### **CITY OF LAREDO**

### **CONSTRUCTION CHANGE ORDER**

PROJECT: CONSTRUCT TAXIWAYS J1 AND J2 AND CHANGE ORDER No. One (1)

DEMOLITION OF A PORTION OF TAXIWAY C

Project Name:	Laredo International Airport	Request No.:	16
	Taxiway J1 & J2		J1 & J2 Demo of Taxiway "C"
	Construction		Removal of Concrete
			Pavement
Project No.:		Date:	02/27/25
Owner:	City of Laredo	Contractor:	REIM Construction, Inc.
	International Airport

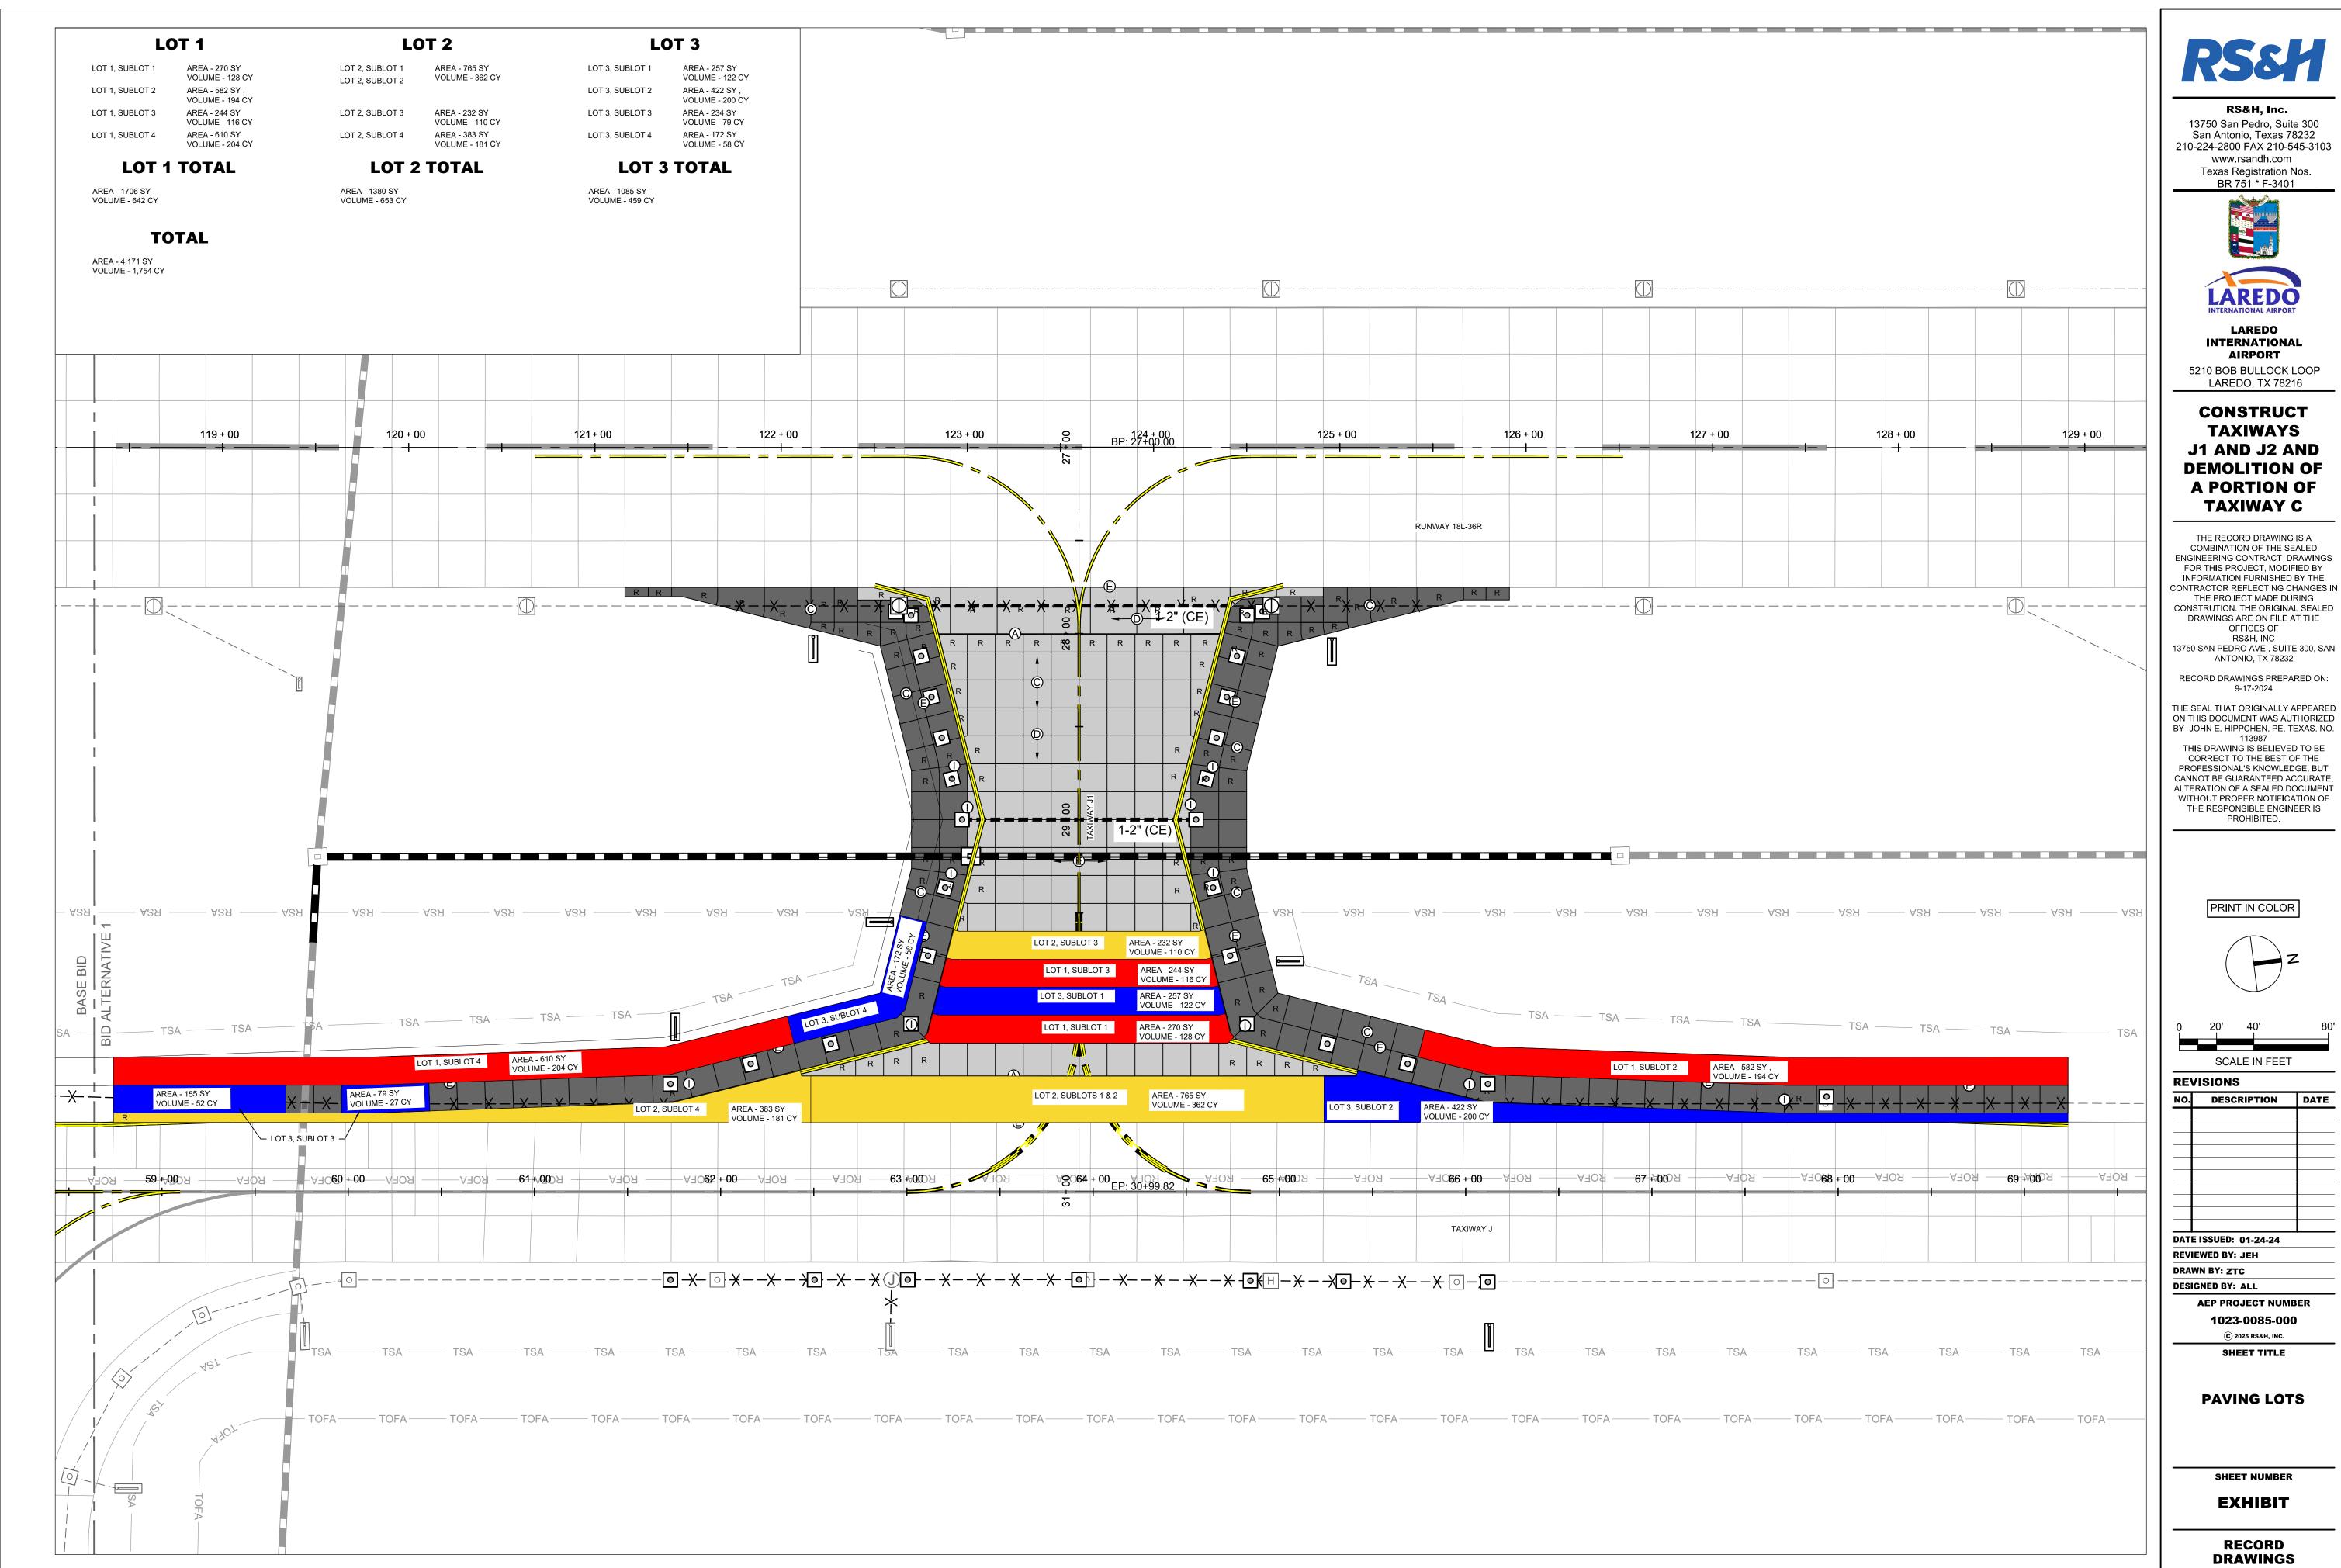
documentation as required):	
Taxiway "C" is asking for a Full Depth Rei	moval of Concrete. Existing Concrete is 15"
with a sub-base of CTB (Concrete Treated	d Base). Can we leave the C.T.B in place but we will
break it down with hammer on excavato	r. Broken up into small portions then soil will be
placed on top and compacted. Finally, we	e will place top soil for seed and sod. For this area
alone REIM is offering \$4,000.00 credit to	o owner.
Please advise.	
Respectfully,	
By: Marco Martinez	Initiated By: X Contractor
By: Maico Mainez	City of Laredo/LAN
Date: <b>02/27/25</b>	
Response to RFI (attach sketches or other o	documentation as required):
Signature:	Initiated By: Contractor
	City of Laredo/RS&H
Date:

The contractor may break through the CTB. The CTB must be completely broken through the entire layer to prevent ponding water on top. The contractor shall hose down the area before covering it to ensure it does not retain water.
